## STATE OF CONNECTICUT CONNECTICUT SITING COUNCIL

Petition No. 1516

# CONNECTICUT GREEN BANK AND CEFIA HOLDINGS, LLC RESPONSES TO THE JUNE 14, 2022 FIRST SET OF INTERROGATORIES DIRECTED TO CONNECTICUT GREEN BANK AND CEFIA HOLDINGS LLC ENFIELD & WILLARD CORRECTIONAL INSTITUTIONS FROM THE CONNECTICUT SITING COUNCIL

## Noise Map - Grid height 2m (A-weighted)

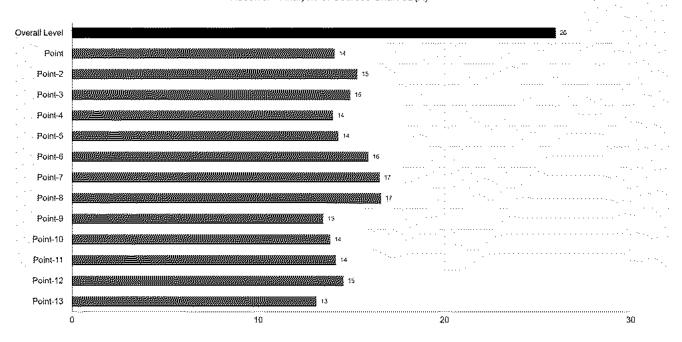
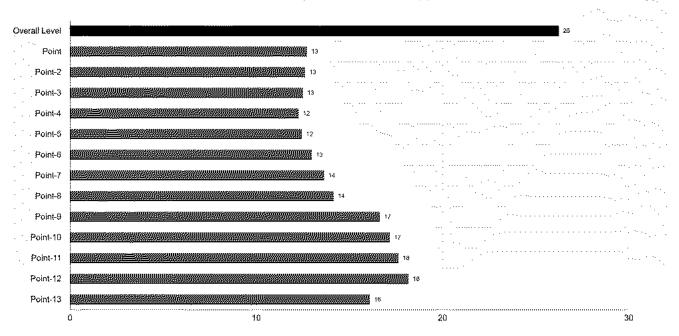
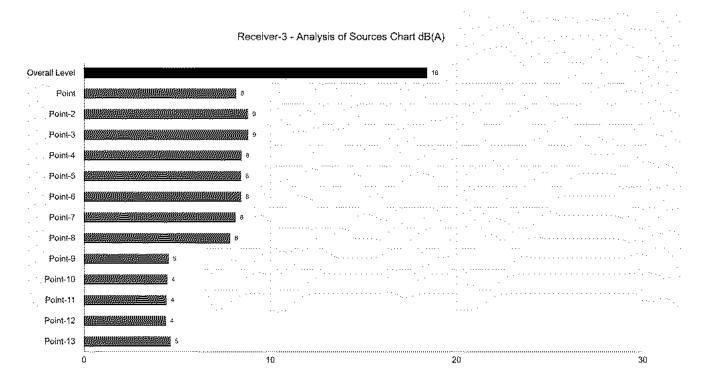
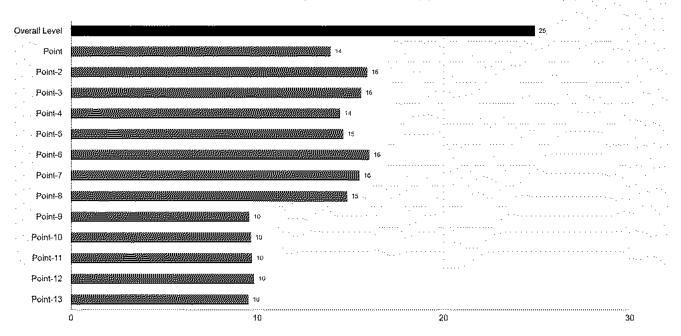
- 9. Referring to Petition p. 16, submit inverter specification sheets that include inverter operational noise characteristics. Using the inverse square law or other noise analysis method, would operational noise meet applicable DEEP Noise Control Standards at the nearest abutting property line?

- a. Inverter specification sheet included (Exhibit 2). Operational noise limits defined by DEEP Noise Control Standards at the nearest property lines are 55dBA during daytime, 45dBA during evening. Based on noise propagation models created with dbmap.net, inverter noise falls under the limit of 45db well within the boundaries of the property line.(Exhibit 3)

Figure 1. Approximate boundaries of Grassland Bird Mitigation Area Complex One, Department of Corrections Somers and Enfield, Connecticut.

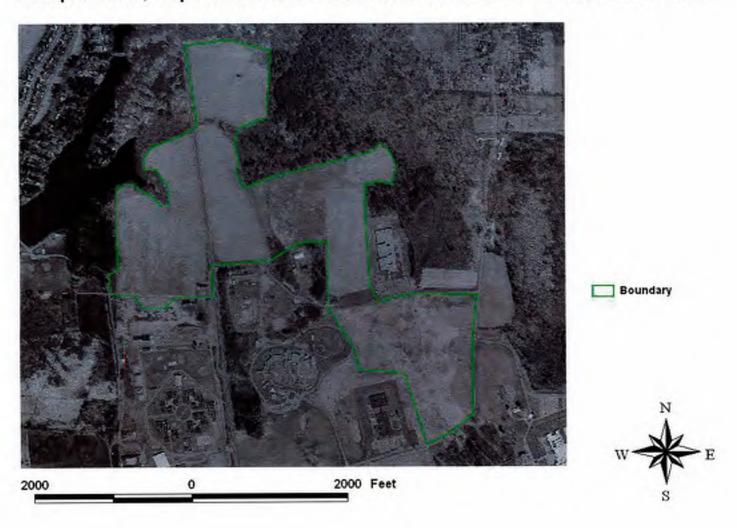
- 13. Page 4 of the Petition and Page 9 of the REMA Species Survey Report (Exhibit IX) references a DEEP conservation area for grassland birds is located off-site to the north, east and west. What is the distance and direction to the grassland bird conservation area from the proposed facility site?

- a. A copy of the map showing the existing Bird Mitigation Area to the north and east of the project area is attached. (Exhibit 4). The closest portion of the Bird Mitigation Area is located to the north and east of the Willard facility. Based on scaling off this map, the proposed work associated with the transmission line from the array to the Willard facility will come to within approximately 80 feet of the Bird Mitigation Area. However, the solar array is over 750' from the Bird Mitigation Area.
